DELEGATED OFFICER REPORT

WOKINGHAM
BOROUGH COUNCIL

Application Number:	252789
Site Address:	23 Fidlers Walk, Wargrave, Wokingham, RG10 8BA
Expiry Date:	13 January 2026
Site Visit Date:	20 November 2025
Proposal: Householder application for the proposed erection of single-storey front extension with 2no. rooflights, garage conversion to habitable space with partial storage and two-storey side extension.

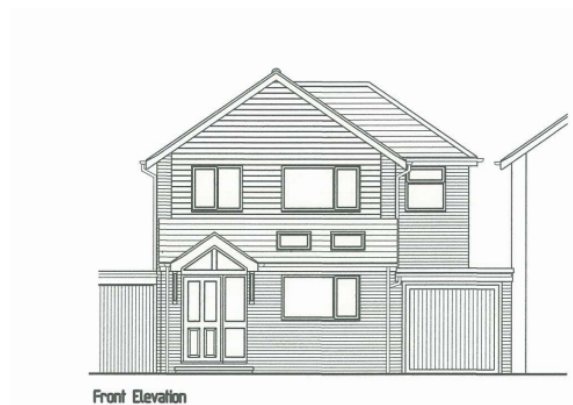
The existing gap between no.23 and no.24 is approx. 2.65m at first floor level. The proposed side extension would have a width of 1.65m, which would reduce this distance to 1m. The side extension would be set back from the building line by approx. 1.10m and would line up with the rear wall. The proposed roof height would be lower and be subservient to the main roof ridge height and the proposed eaves height would tie in seamlessly with the existing eaves height.

Due to the side gap of 1m and proposed hipped roof design, the proposal would not create a terracing affect with no.24 when view from the street scene. The proposed side extension would respond positively to the host dwelling and would contribute positively to the local character of the area.

Furthermore, a similar proposal has previously been approved at 19 Fidlers Walk (162209- figure on left). It's clear the proposal has taken design inspiration from no.19 and therefore would not look out of place in the street scene.
